Environmental Restoration Program

Second Five-Year Review Report

Operable Unit 6

SUBJECT: Final Second Five-Year Review Report, National Aeronautics and Space Administration, Armstrong Flight Research Center, Operable Unit 6, Edwards Air Force Base, CA

Site N2 Exposure Pathways Retained For A CERCLA Response		
Date 08-2011	Operable Unit 6 First Five-Year Review Report Edwards AFB	Figure
Project No. 60133976		7-1

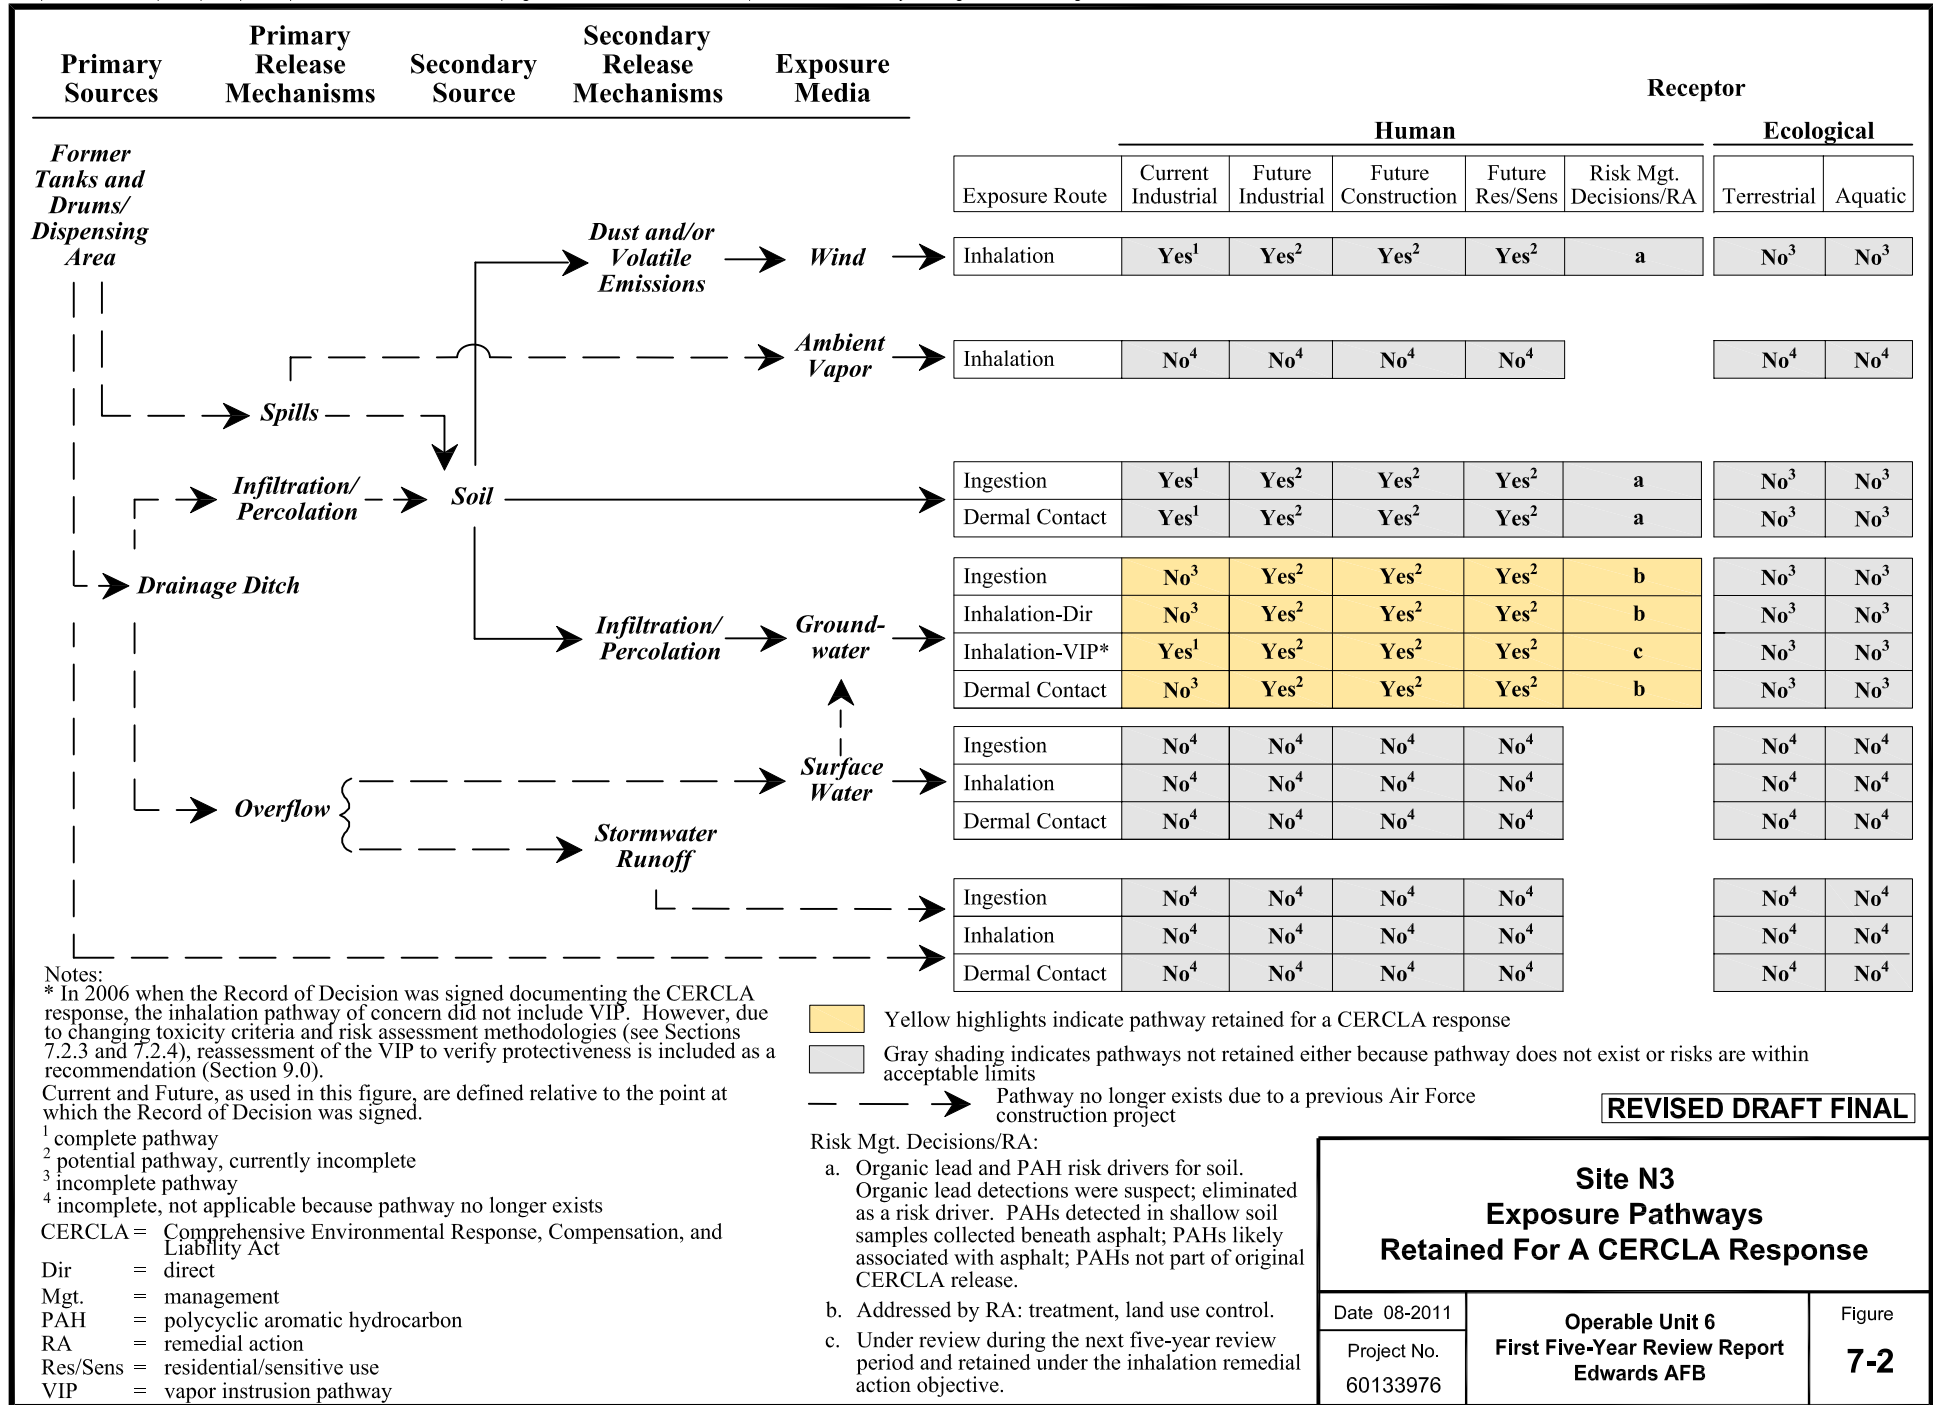
pathways or receptors were identified during the five-year review and no weather-related events have affected the protectiveness of the remedy." Similarly, Lines 15-16 on Page 8-1 states that no exposure pathways exist. However, Figures 7-1 (Site N2 - Exposure Pathways) and 7-3 (Site N7 - Exposure Pathways) show complete pathways for the current industrial worker exposure route for groundwater inhalation.

- c. Figures 7-1 to 7-3 have been revised to clearly indicate which exposure pathways are being addressed by the remedy. The document has been revised to consistently present that complete exposure pathways are controlled through institutional controls that are preventing exposure to, and the ingestion of, contaminated groundwater.
